**1 DETAILS OF THE DEVELOPMENT**

Ref: 19/02842/PRE  
Location: Croydon College Annexe, College Road, Croydon, CR9 1DX  
Ward: Fairfield  
Description: Mixed redevelopment of the site to provide circa 90 flats and a 'Cultural and creative industries enterprise centre'  
Applicant: Stonegate Homes  
Agent: Montagu Evans  
Case Officer: Katy Marks

**2 EXECUTIVE SUMMARY**

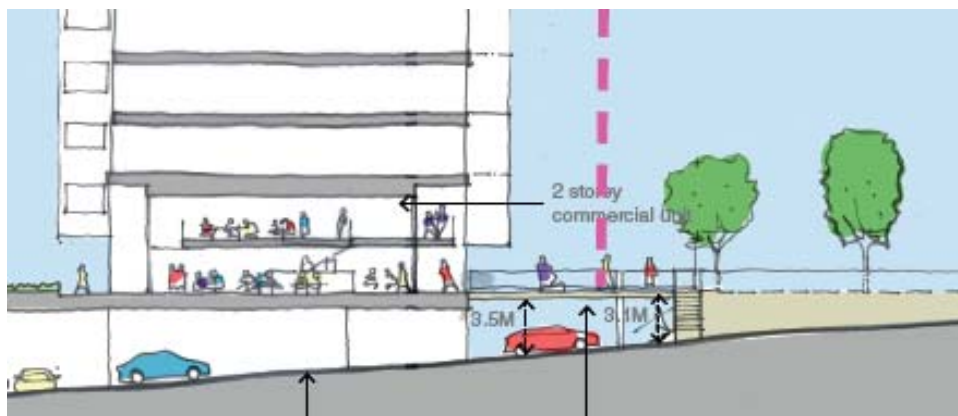
- 6.17 Officers previously requested that the applicant undertakes a comprehensive character appraisal of the area to guide further design development. Initial design development was based upon the angular saw tooth design of the existing building and acoustic panels within Fairfield Halls. Wider consideration of buildings within the CMC has focused upon strong examples of mid-20<sup>th</sup> Century architecture which is considered appropriate given the relationship with Fairfield Halls and the existing building.
- 6.18 The elevational treatment and materials have been simplified since the PRP feedback. The taller element is proposed to make use of pre-cast concrete

panels with texture to reference the ribbed concrete panels of the existing building. The lower element would make use of a light coloured brick which would provide some differentiation to this element and give it a softer appearance which is generally supported given its more modest scale.

- 6.19 PRP suggested that consideration should be given to use of pure and applied arts within the architectural surface, working with the sculptural qualities of the proposed materials and use of public art. This is particularly relevant given the historic use of the site. The applicant has begun to consider how this could be incorporated into the design of the building. Officers feel that there is opportunity to introduce public art into the architectural surface of the concrete and within the public route through the site particularly within the soffit of the under-croft.

- 6.20 The applicant has sought to give the enterprise centre at ground and first floor a different character to the rest of the building, with the idea that it would sit nestled under the main frame of the building. The form and façade design of this space is under review but the applicant has, in the most recent iteration, simplified the design of this space to provide more of a relationship between it and the rest of the building which also improves the quantum of internal space for the enterprise centre.

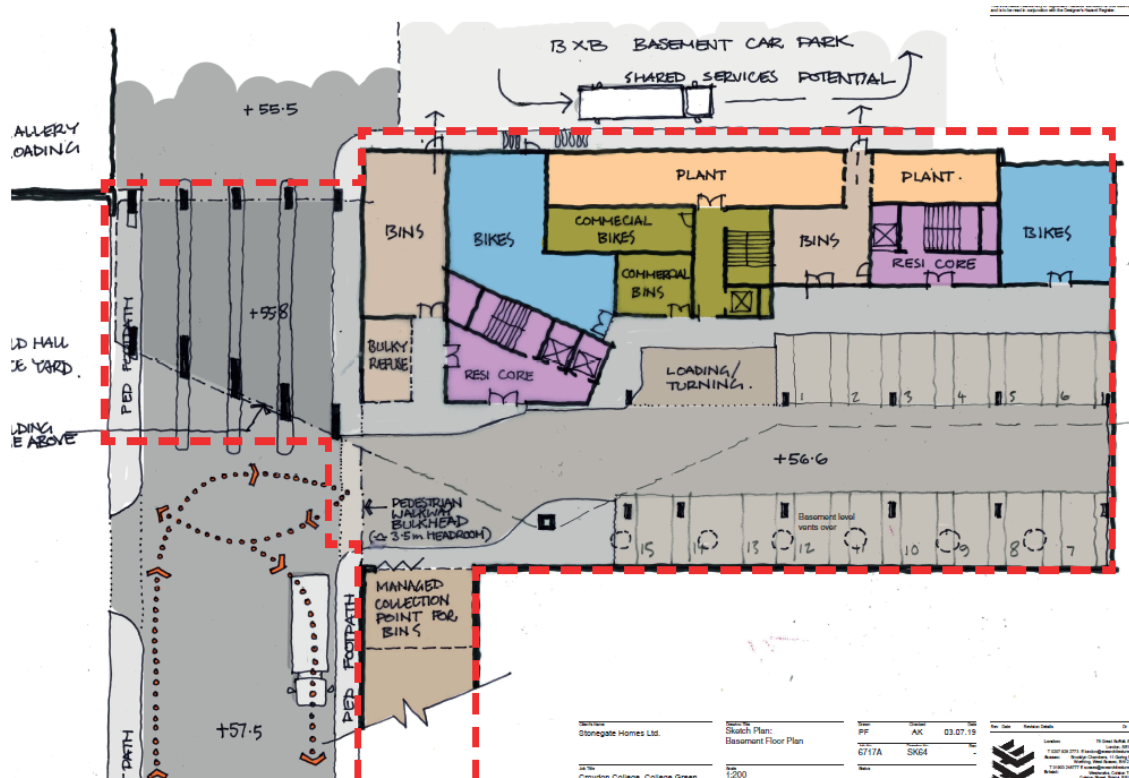
- 6.37 In addition, officers have some concerns that the proposed servicing plans could give rise to conflict between the development and existing uses. These are detailed in the transport section below.
- 6.38 It should be noted that the Magistrates Court formed part of the outline consent for the hybrid permission and it is considered to have some redevelopment potential. It also currently has windows in the rear elevation. The proposed development is considered to be located sufficiently away from the southern boundary of the site to ensure that it would be unlikely to prejudice a future redevelopment of this site nor result in privacy issues for the proposed flats (or result in a poor relationship with the existing windows). The current layout allows the scheme to maximise the landscaping potential and access arrangements to the south of the building.
